## **Access Compliance Report Public Rights-of-Way** (Curb Ramps)

Intersection ID: 13474 Main Street: OLD\_STEELE\_CREEK\_RD **Cross Street: MARENE DR** Location: NW ADA ID: 2421FAB89A28 Ramp Type: ParaDiag Initial Pass/Fail: Fail **Overall Compliance: No Severity Score:** 22.5

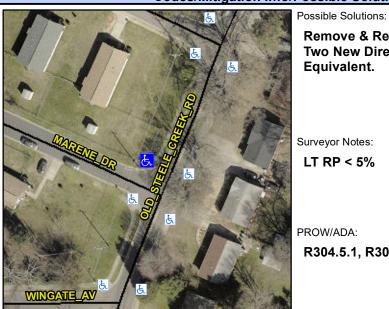
LT RP < 5%

R304.5.1, R304.5.3, R304.3.2

Compliance Description		Data	Comp	oliance Description	Data
N/A	Ramp Length LT (in)	109.0	N/A	Ramp Length RT (in)	106.0
Yes	Ramp Width LT (in)	52.0	No	Ramp Width RT (in)	45.0
Yes	Ramp Slope LT (%)	0.1	No	Ramp Slope RT (%)	11.5
No	Ramp XSlope LT (%)	3.1	No	Ramp XSlope RT (%)	3.4
N/A	Landing Length (in)	N/A	N/A	DWS Provided?	N/A
N/A	Landing Width (in)	N/A	N/A	DWS Contrast?	N/A
N/A	Landing Slope (%)	N/A	N/A	DWS Length (in)	N/A
N/A	Landing X Slope (%)	N/A	N/A	DWS Full Width?	N/A
N/A	Landing Curb? (Y/N)	N/A	N/A	DWS Offset (in)	N/A
N/A	Shared Landing?	N/A			
N/A	Gutter Ponding?	N/A	N/A	Gutter Slope (%)	N/A
N/A	Gutter Lip Ht (in)	N/A	N/A	Gutter X Slope (%)	N/A
N/A	Painted X Walk1?	No	N/A	Painted X Walk2?	No
	X Walk 1 Direction	To S		X Walk 2 Direction	To E
N/A	X Walk 1 Width (in)	N/A	N/A	X Walk 2 Width (in)	N/A
	X Walk 1 Slope (%)	1.3		X Walk 2 Slope (%)	5.2
	X Walk 1 X Slope (%)	4.3		X Walk 2 X Slope (%)	2.1
N/A	Ramp inside XWalk1?	N/A	N/A	Ramp inside XWalk2?	N/A

Street 1 Name Stop Condition-Stree Street 2 Name Stop Condition-Stree Remove & Replace Curb Ramp With Two New Directional Ramps or Equivalent.
